Nuclear Regulation Authority

1-1-3 Uchisaiwai-cho, Chiyoda-ku, Tokyo Tokyo Electric Power Company Holdings Inc. President Tomoaki Kobayakawa

Partial Revision of the Application for approval to amend the Implementation Plan for Fukushima Daiichi Nuclear Power Station as Specified Nuclear Facility

TEPCO partially revise Application for approval to amend the Implementation Plan for Fukushima Daiichi Nuclear Power Station as Specified Nuclear Facility, which submitted on Dec. 21, 2021 (Application No. FDEC-R3-175) and partially revised on Apr. 28, 2022 (Application No. FDEC-R4-23) and May 13, 2022 (Application No. FDEC-R4-38), as per the attached document.

Fig. 2 Plans for monitoring seawater inside and outside port and groundwater (sampling points)

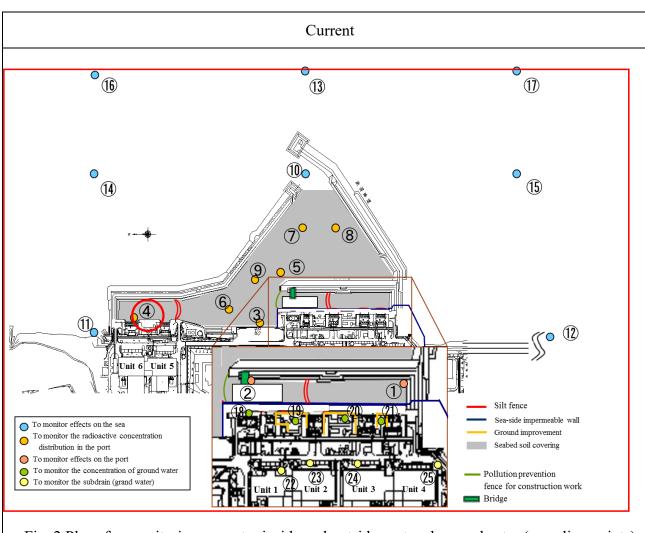
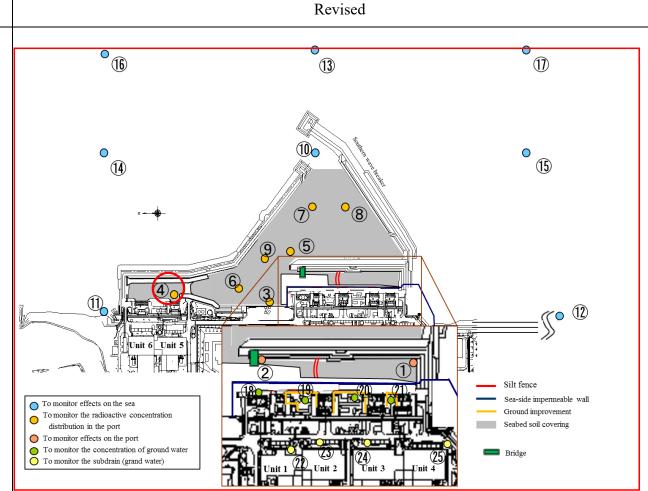
Reason for Revision Current Revised 3.1.4 Reduction of radioactive materials in seawater, seabed soil, groundwater and drainage channels 3.1.4 Reduction of radioactive materials in seawater, seabed soil, groundwater and drainage channels in ports and harbors in ports and harbors (Omission) (Omission) 3.1.4.3 Basic Approach to Reduction Measures 3.1.4.3 Basic Approach to Reduction Measures (Omission) (Omission) (3) Measures to reduce the concentration of radioactive materials in water in drains (3) Measures to reduce the concentration of radioactive materials in water in drains (Omission) (Omission) (4) Measures to reduce the radioactive concentration of seawater intake for ALPS treated water Addition of measures to dilution/discharge facilities and related facility reduce radioactive materials Fig. 4 shows the conceptual diagram of the seawater intake facility. As for the water intake method in seawater intake in the water intake canal of Units 5 and 6 will be partitioned from the port of power station on the accordance with the side of the water intake canal of Units 1 to 4 with a partition dike (the riprap sloping weir + sheet) installation of ALPS treated and a part of the north side of the North Breakwater Permeation Prevention Work will be modified water dilution/discharge (partially removed), and seawater for dilution will be intake from outside the port of power station facilities and the related on the north side of the outlet of Units 5 and 6. By constructing partition dike, the inflow of seawater facility with a relatively high concentration of radioactive materials from the side of the water intake canal of Units 1 to 4 will be suppressed. Addtion of installation of partitioning dikes for discharge of ALPS treated water into the sea Optimization of the description (reflection of drawings in line with actual conditions of the site) Unit 5/6 drainage outle fence for construction work Sea-side impermeable wall Ground improvement Ground improvement Seabed soil covering Seabed soil covering Fig. 1 Measures to Reduce Radioactive Materials in Seawater and Seabed Soil in the Port, and Fig. 1 Measures to Reduce Radioactive Materials in Seawater and Seabed Soil in the Port, and Groundwater Groundwater
